Access Compliance Report

Public Rights-of-Way

(Pedestrian Signals)

Intersection ID: N/A	Main Street:	Cross Street: N/A	Location: N/A
ADA ID: 8914BF8F9309	Signal Type: One Push Button-Non APS	Overall Compliance: No	Severity Score: BTN 1: N/A BTN 2: N/A No BTN: N/A
Codes/Mitigation Info/Possible Solution		Field Measurements/Component Compliance

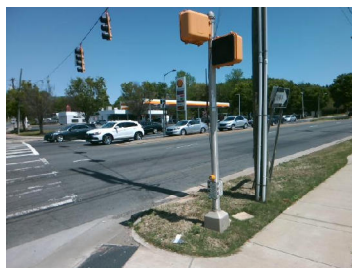
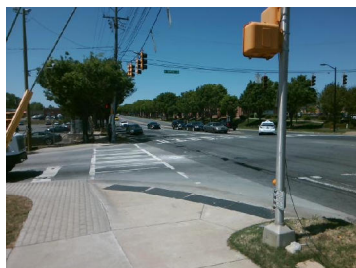
PROW/ADA: R404.7.3

Possible Solutions: Remove and Replace Clear Space.
